Final Technical Plan
July 1988

LITIGATION TECHNICAL SUPPORT AND SERVICES

Rocky Mountain Arsenal

Offpost Remedial Investigation/Feasibility Study

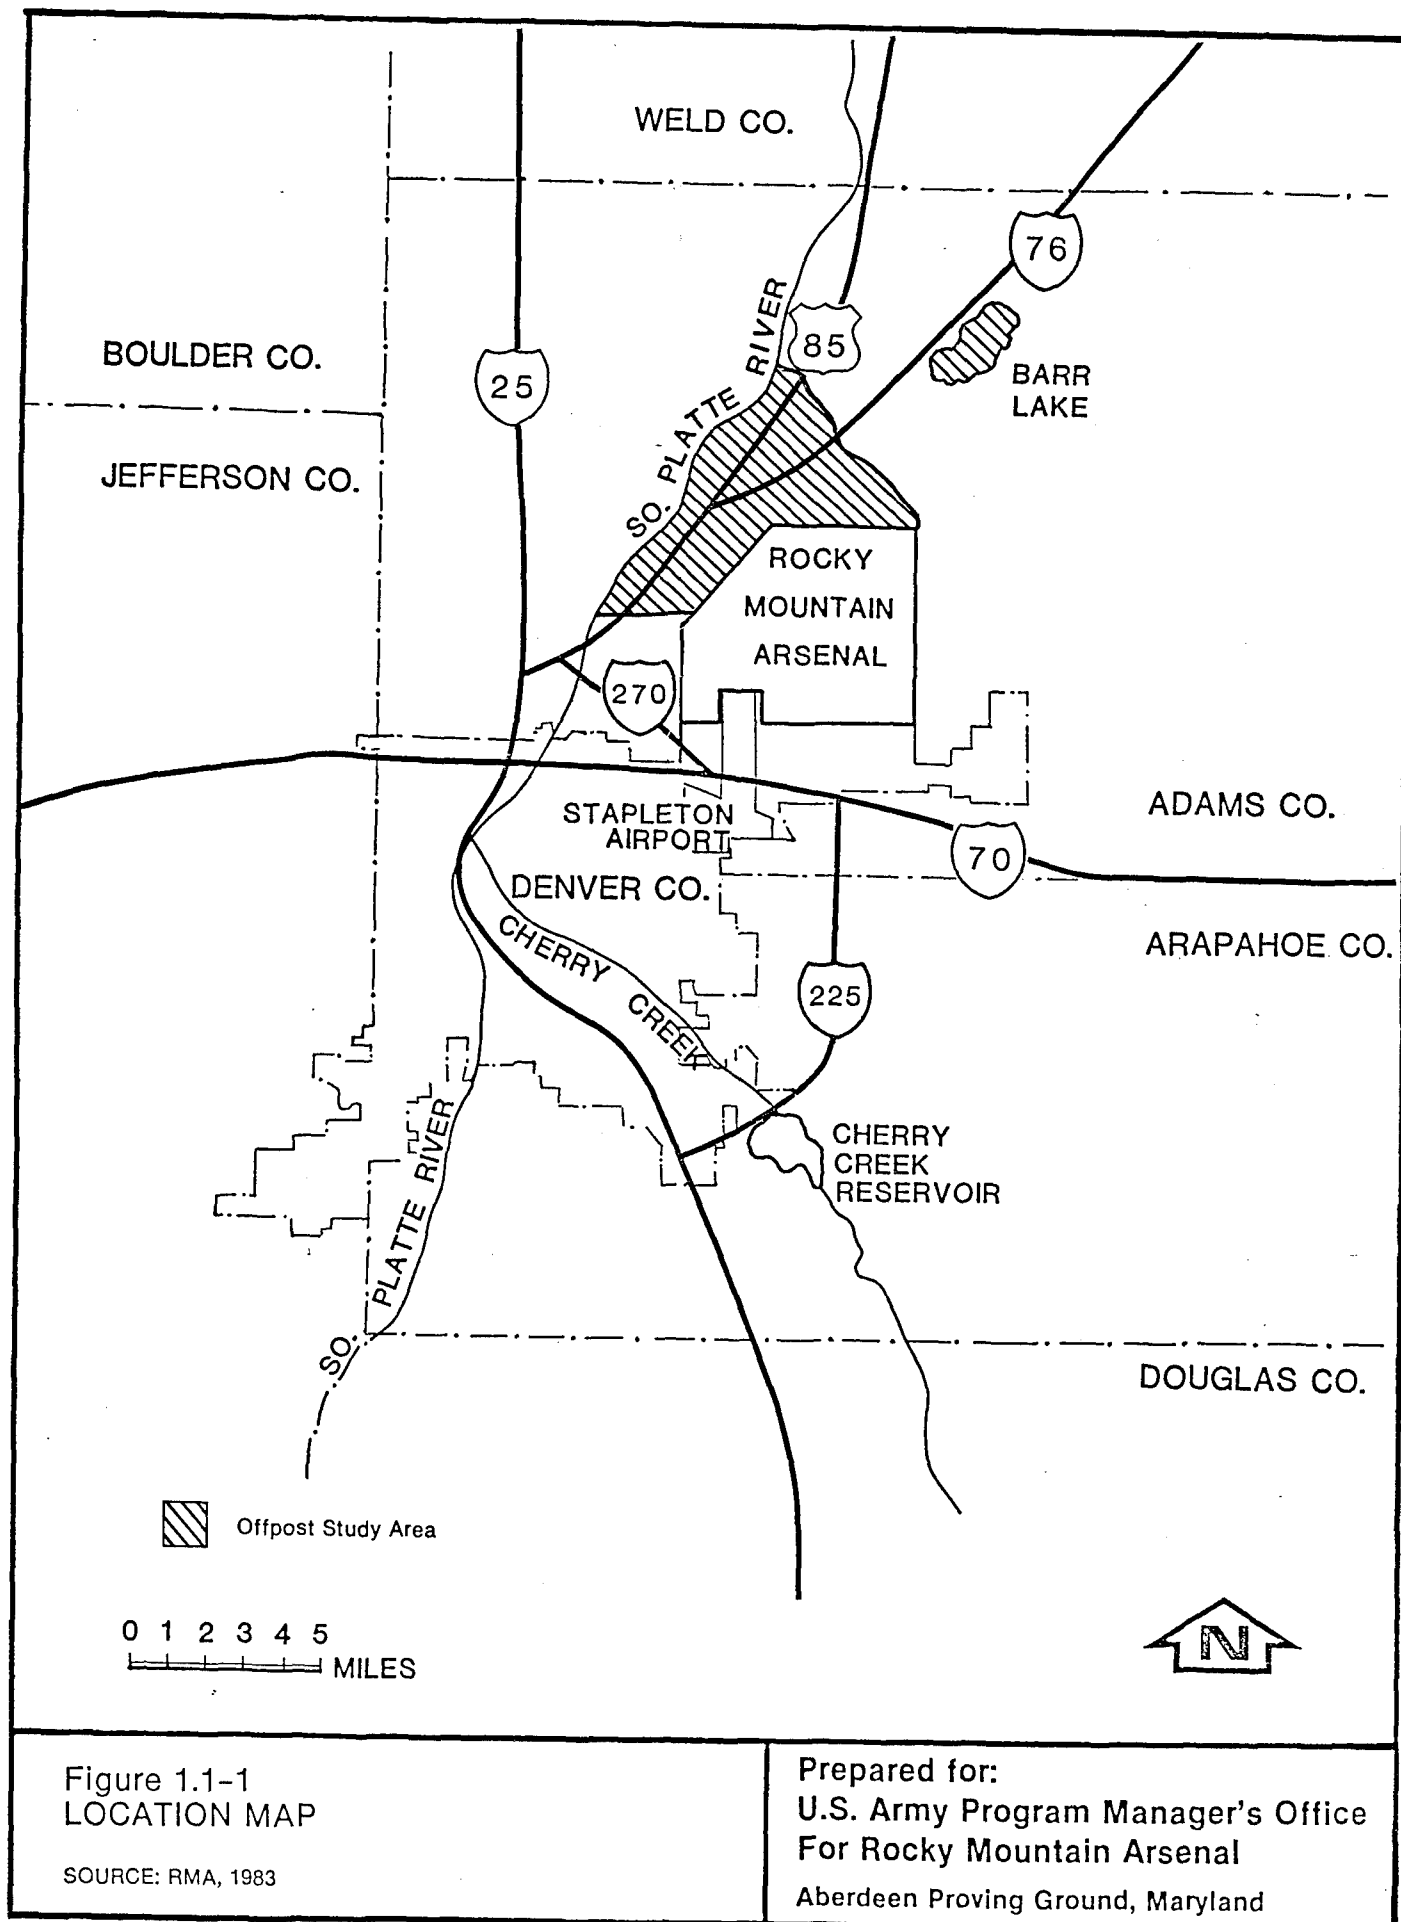
Comment 2: The Off-Post RI study area should be shown for reference
Page 1-5, to regional features to supplement Figure 1.3-1.
Figure 1.1-1

Response: The offpost study area will be shown on Figure 1.1-1 in
the Final Technical Plan.

Figure 1.3-1
OFFPOST STUDY AREA

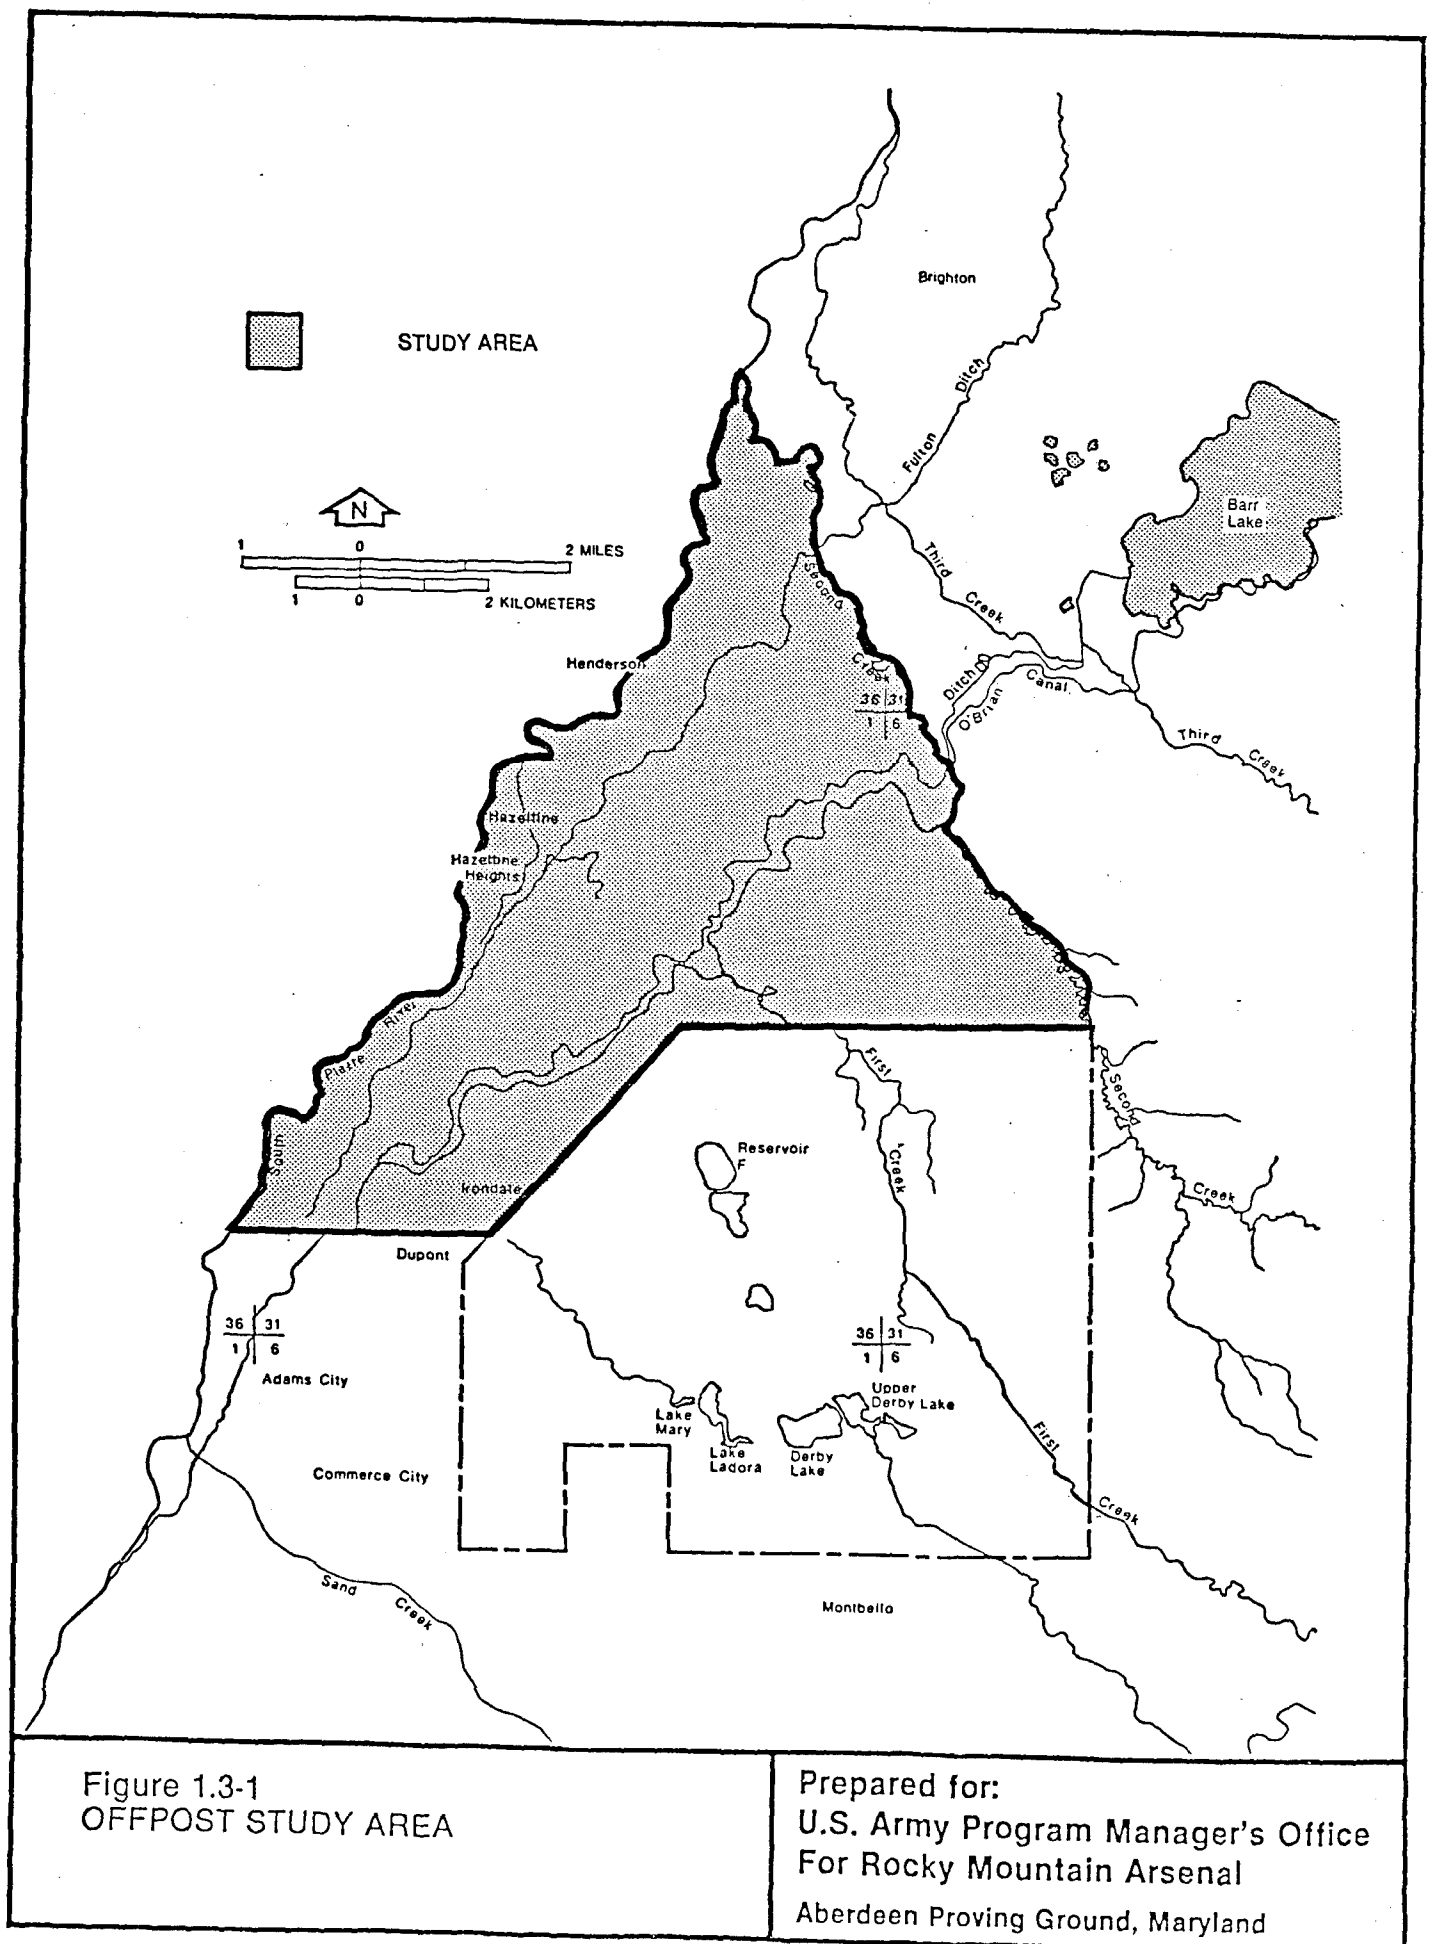
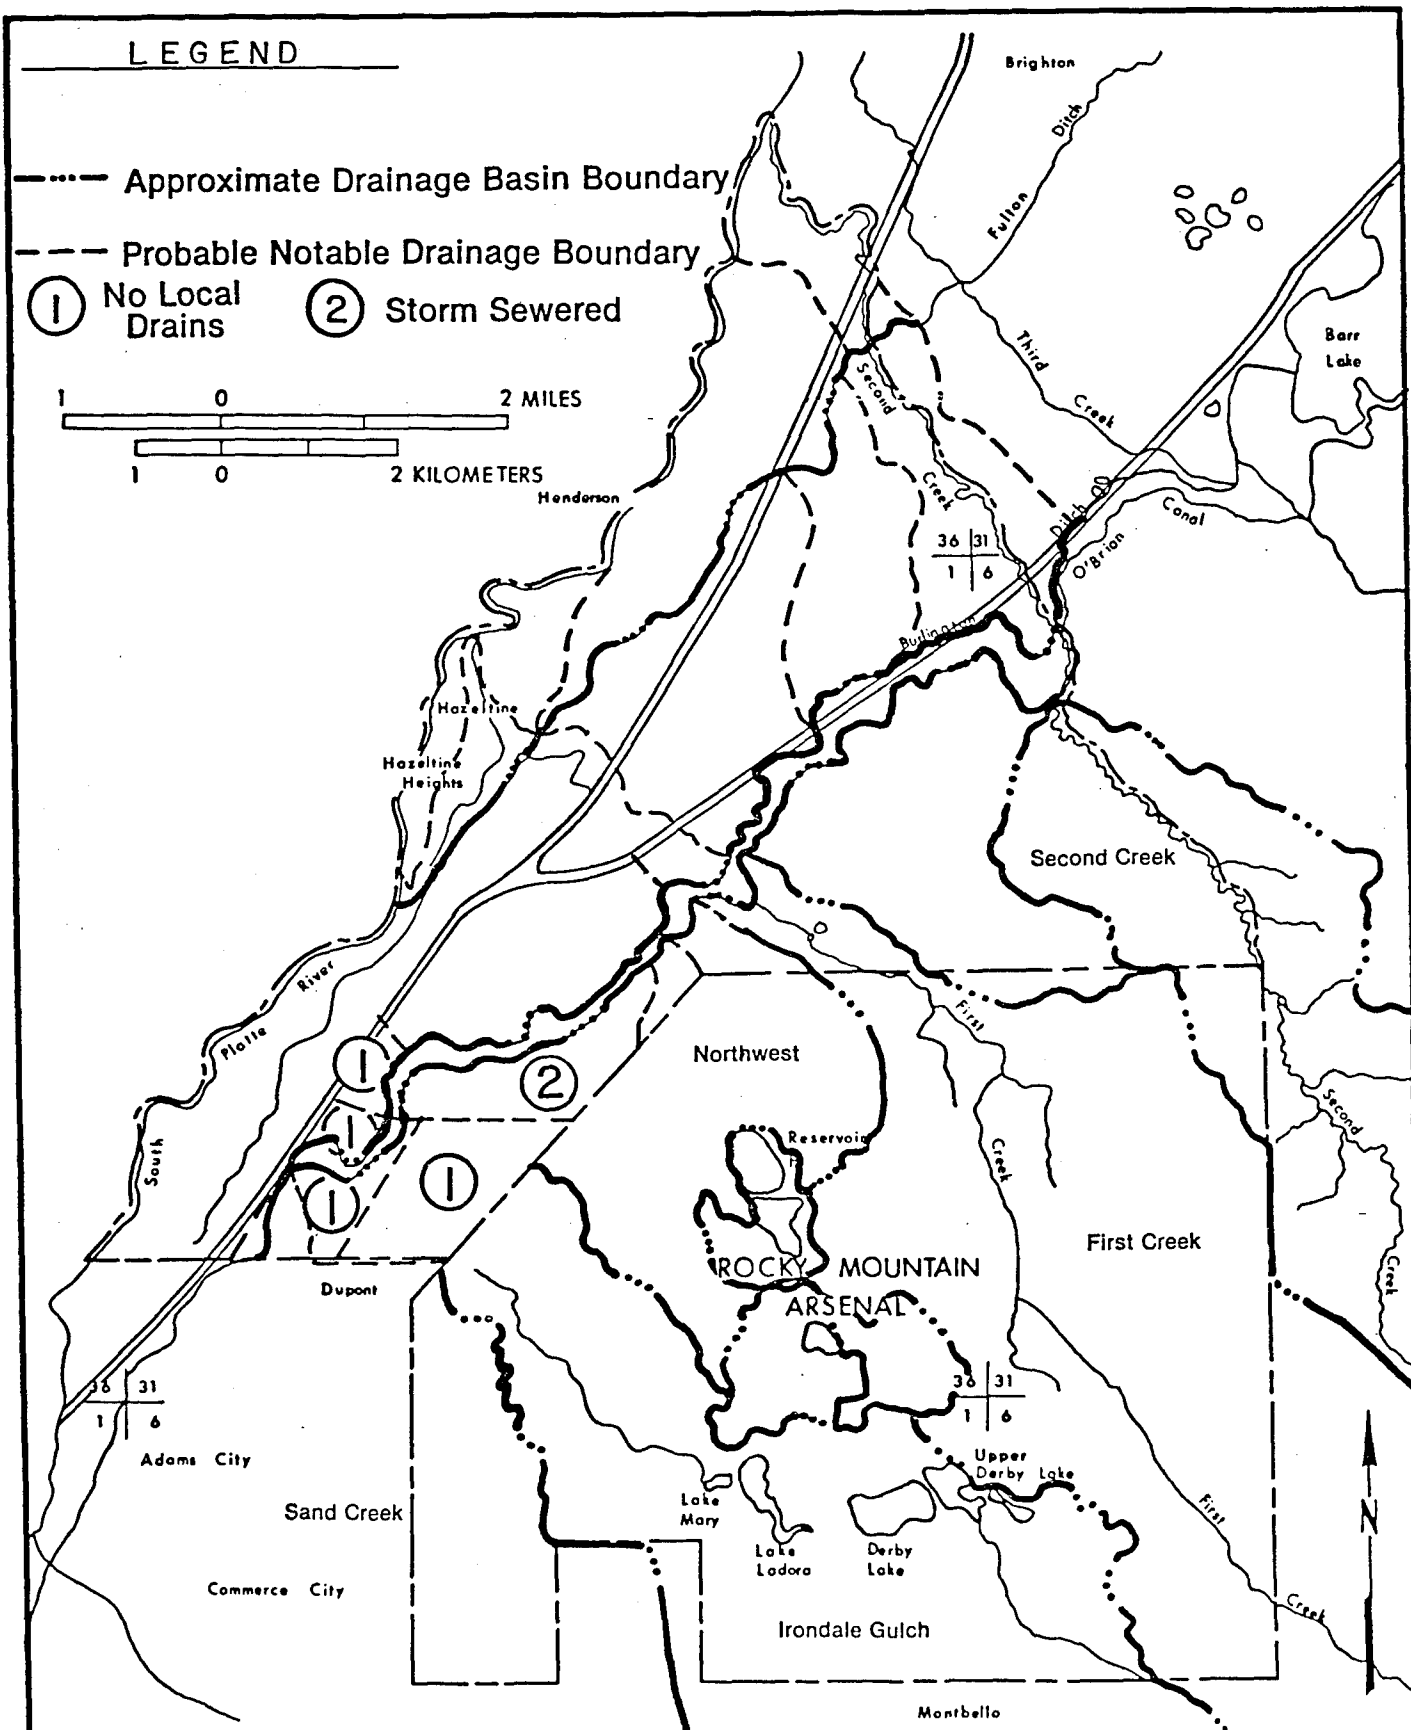
Comment 4: The text indicates that the O'Brian Canal and Burlington Ditch intersect Second Creek. Yet Figures 1.3-1 and 1.3-2 indicate that Second Creek continues to the South Platte River.
Page 1-11,
Top of Page

Figure 1.3-7
ELEVATIONS OF BEDROCK SURFACE

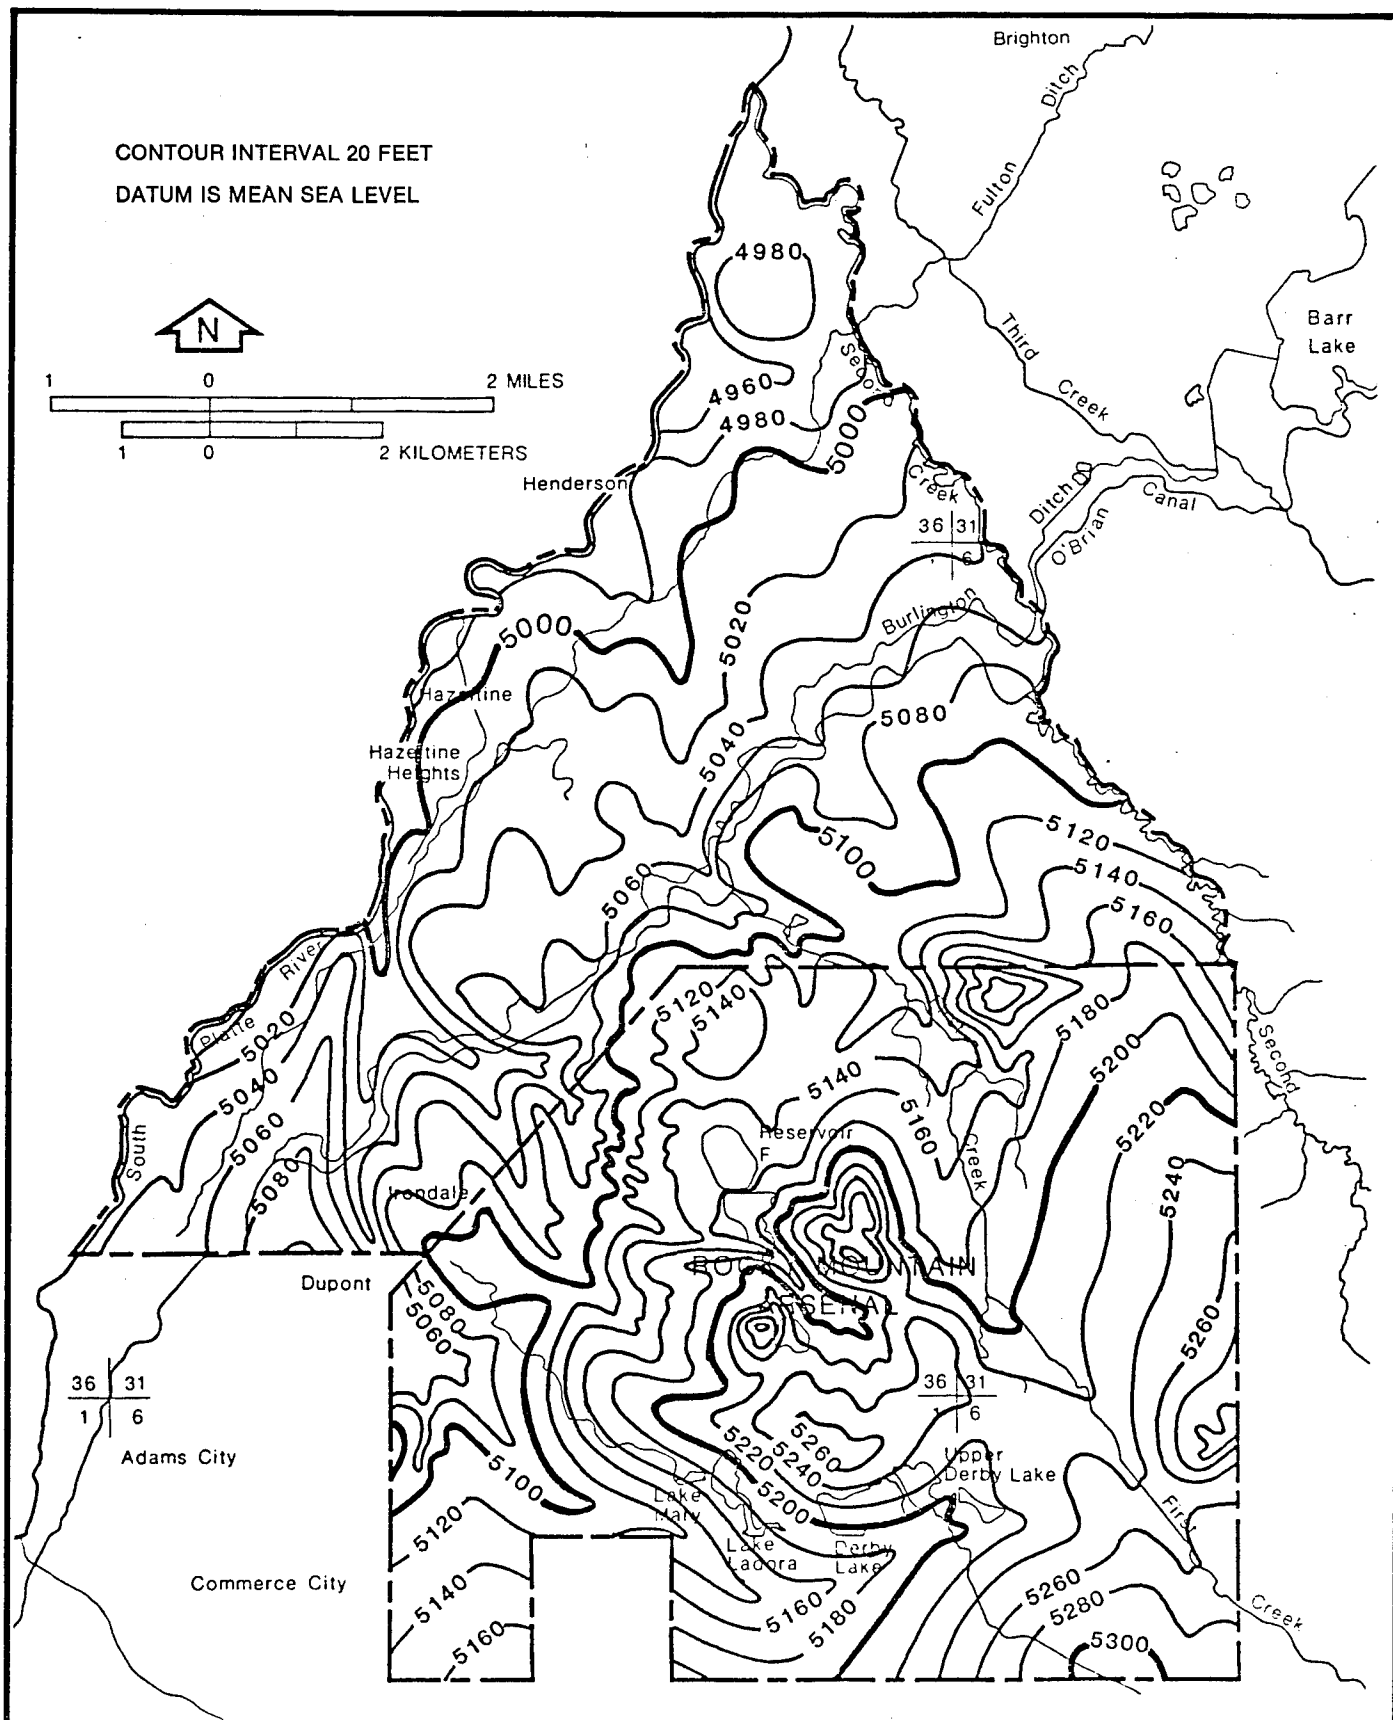
The text and Figure 1.3-7 should indicate that elevations of bedrock surface are "preliminary" drawings or estimates of the orientation of paleochannel depressions because they are based on a limited amount of data.
